**ANALYSIS PREPARED BY THE  
PUBLIC SERVICE COMMISSION OF WISCONSIN**

## **TEXT OF PROPOSED RULE**

Figure PSC 114-317B1.

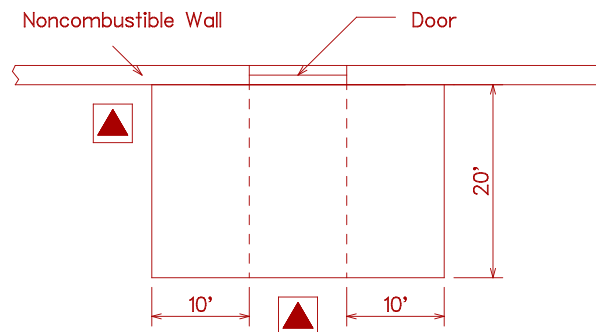
1. Padmounted oil-insulated transformers shall not be located within a zone extending 6.1 m (20 ft) outward and 3.0 m (10 ft) to either side of a building door. See Figure PSC 114-317B1.

Figure PSC 114-317B2.

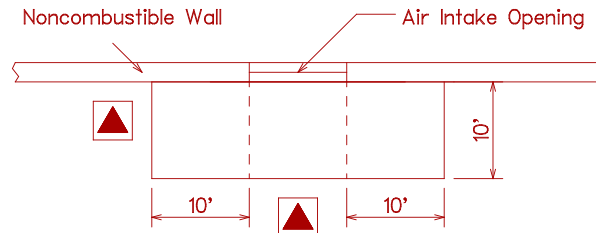
2. Padmounted oil-insulated transformers shall not be located within a zone extending 3.0 m (10 ft) outward and 3.0 m (10 ft) to either side of an air intake opening. Such transformers may be located within said zone beneath an air intake opening provided there is not less than 7.6 m (25 ft) diagonal separation between the transformer and said opening. See Figure PSC 114-317B2.

Figure PSC 114-

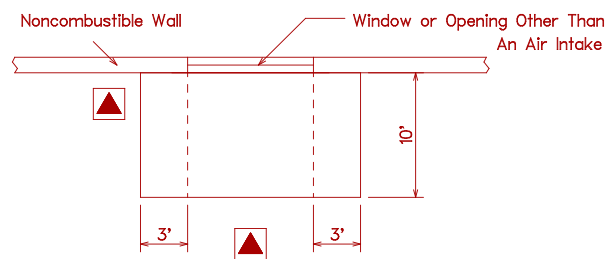
3.a. Padmounted oil-insulated transformers shall not be located within a zone extending 3.0 m (10 ft) outward and 0.9 m (3 ft) to either side of a building window or opening other than an air intake. See Figure PSC 114-317B3a.

Exception: This does not apply to a glass block or fire window meeting the requirements of the Wisconsin Commercial Building Code (Fire Window IBC Chapter 7, Section 714.3).

Figure PSC 114-317

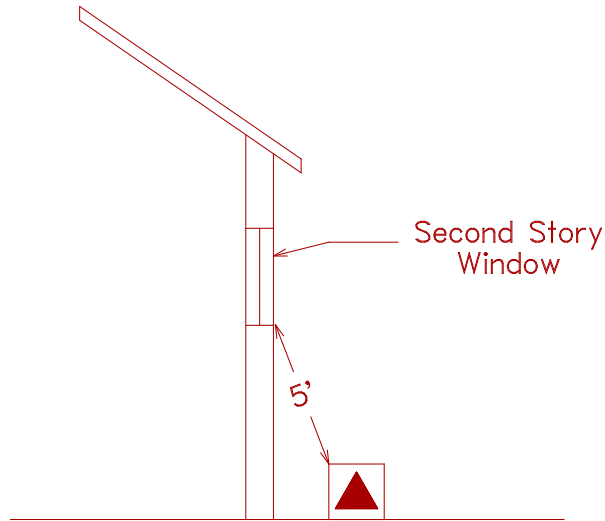
3.b. For second story windows, the transformer shall not be located less than 1.5 m (5 ft) from any part of the window. See Figure PSC 317B3b.

Exception: This does not apply to a glass block or fire window meeting the requirements of the Wisconsin Commercial Building Code (Fire Window, IBC Chapter 7, Section 714.3).

Figure PSC 114-

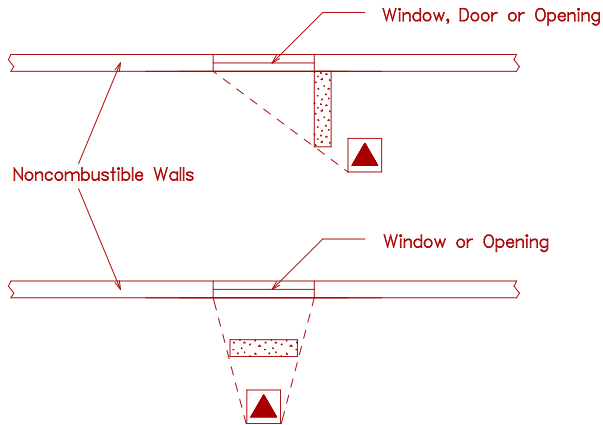
The barrier shall extend to a projection line from the corner of the padmounted transformer to the furthest corner of the window, door or opening in question. The height of the barrier shall be 0.3 m (1 ft) above the top of the padmounted transformer. See Figure PSC 114-317D1.

Figure PSC 114-317D2.

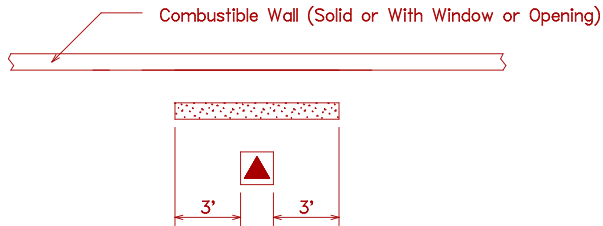
The barrier shall extend 0.9 m (3 ft) beyond each side of the padmounted transformer. The height of the barrier shall be 0.3 m (1 ft) above the top of the transformer. See Figure PSC 114-317D2.

Figure PSC 114-317E2

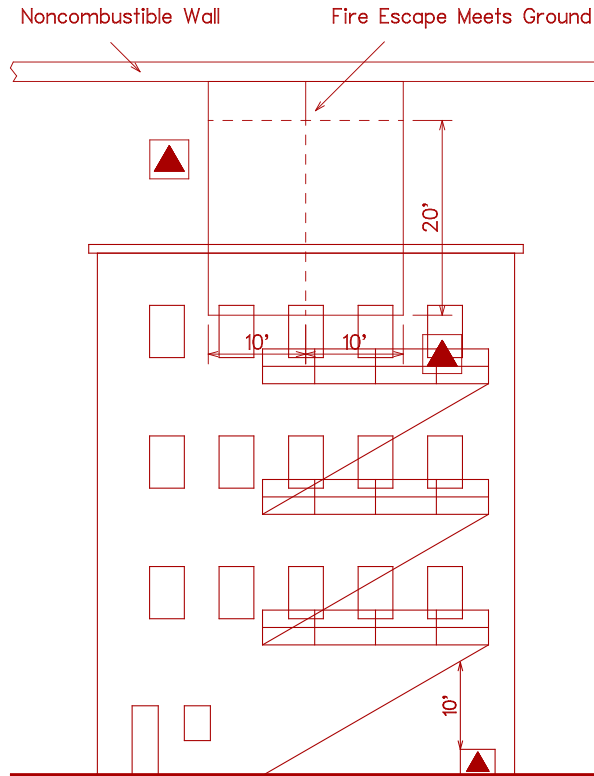
1. Padmounted oil-insulated transformers shall not be located within a zone extending 6.1 m (20 ft) outward and 3 m (10 ft) to either side of the point where a fire escape meets the ground. See Figure PSC 114-317E1.

2. Padmounted oil-insulated transformers located beneath fire escapes shall have a vertical clearance of not less than 3 m (10 ft) from the top of the transformer to the bottom of the fire escape. See Figure PSC 114-317E2.
